**Request for Additional Information: Section 117(3) of the Maritime Area Planning Act 2021**

**Maritime Usage Licence Application Reference: MUL260023**

Image 1 - self-intersecting polygon error.

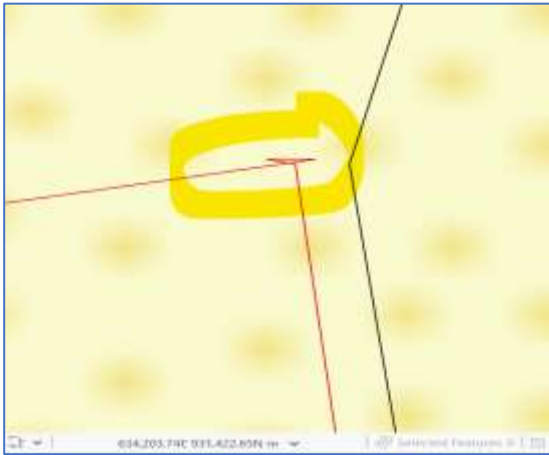
- Ensure that the GIS shapefile represents area data with no mapping anomalies such as self-intersecting polygons (see example in Image 1 below.)
- Ensure the GIS shapefile represents the footprint of the maritime area that the maritime usage will occupy below the High-Water Mark as defined by the Chief Boundary Surveyor, not extending into terrestrial land (see examples in Image 2 & 3 below).
- Recalculate the Proposed MUL Area and display it on the Proposed MUL Map.
- The High Water Mark as defined by the CBS is available at:  
<https://arcg.is/1zSran1>
- Adhere to the **MARA Technical Mapping Guidance Note for MAC/MUL Applications** available at:  
[MARA Technical Mapping Guidance for MAC MUL Applications-vm26.pdf](#)
